# Town of Hamburg Planning Board Public Hearing

**Site Plan Application**

**November 20, 2024**

**Applicant** Alliance Homes

**E-MAIL FROM CHRIS HULL (BIG TREE  
VFC CHIEF) DATED OCTOBER 1, 2024:**

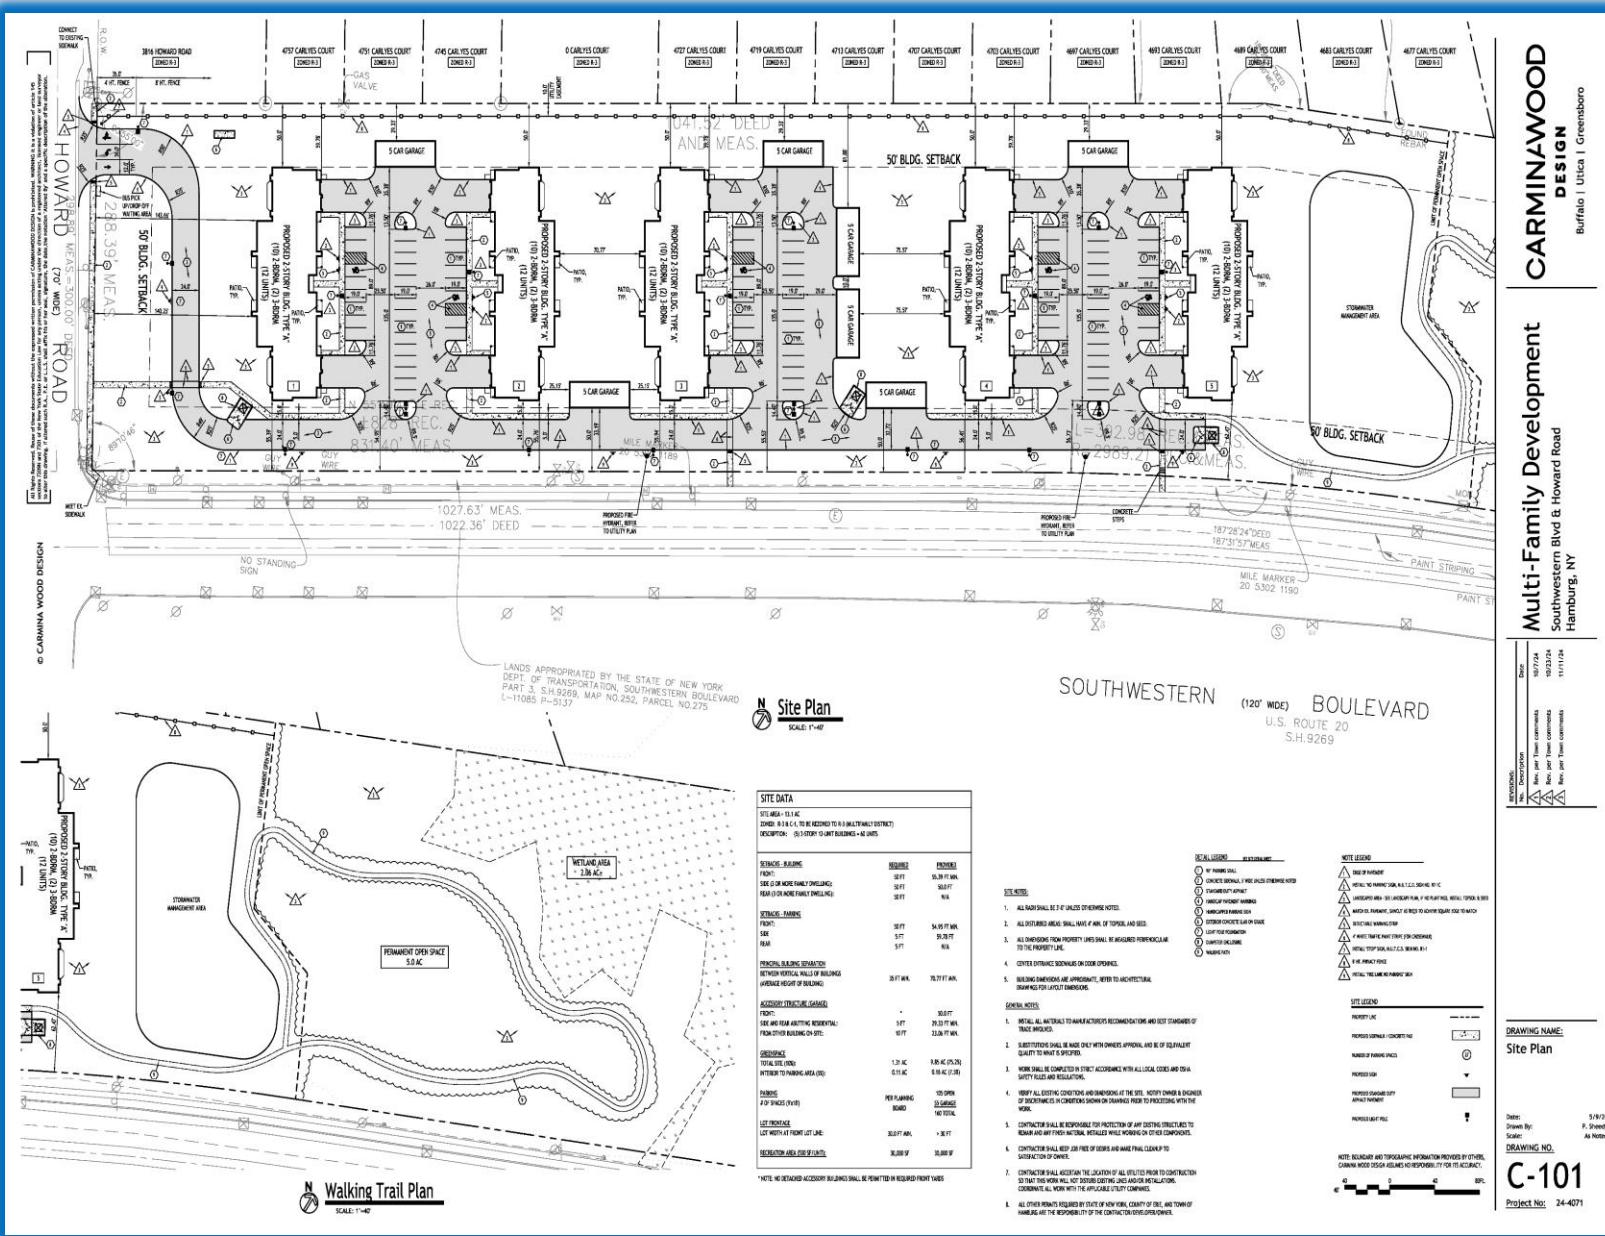
- **Comment No. 3:** *Questioning if the end of Howard Road that leads into Southwestern Blvd should be widened and a left had turn lane added for traffic safety and volume.*
- **Response:** The driveway connection was previously widened to a 3 lane (1 ingress, 2 egress) as shown on the Site Plan Drawings previously submitted on October 9th.
- **Comment No. 4:** *Requesting no parking signs be added to the complex road to help prevent parking issues that create congestion in needed responses.*
- **Response:** Fire Lane no parking signs were previously added to the Site Plan Drawings submitted on October 9th.

**Color Building Rendering Plan  
prepared by Sutton Architecture:  
dated September 5, 2024, based on  
input from the Town Board:**

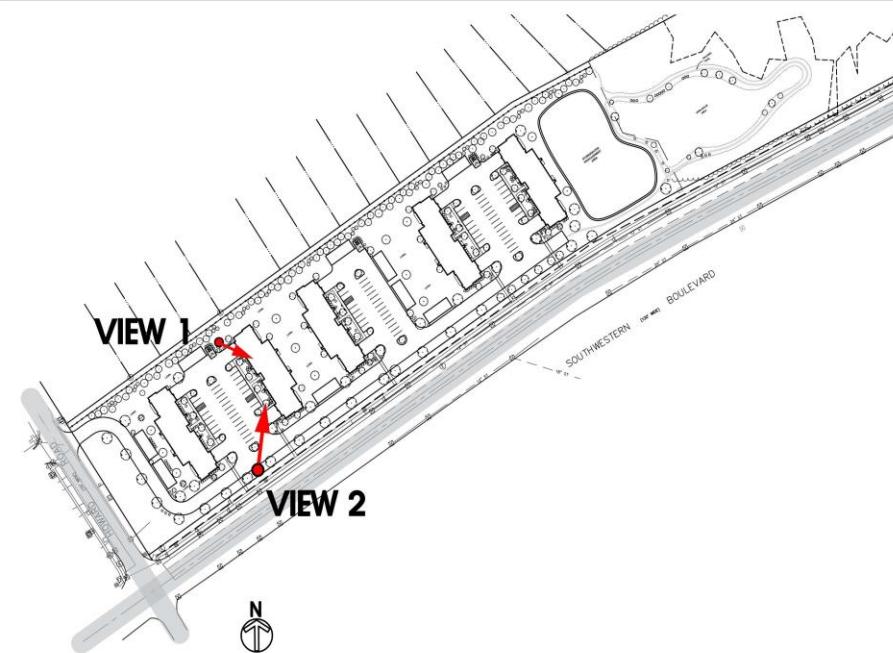
- 1. Bump out with a depth of approximately 1 ft. was added on the front elevation of the building
- 2. Bump out with a depth of approximately 2.5 ft. was added on the sides of the building.
- 3. The brick water table was wrapped around the Southwestern Boulevard side of the building.
- 4. Four different colors and building materials have been utilized consisting of cedar impression siding, two tone siding and the brick water table.
- 5. Brick on the front façade has been increased for the entry of the first floor.
- 6. Metal railings have been added to the balconies instead of wood as previously depicted.
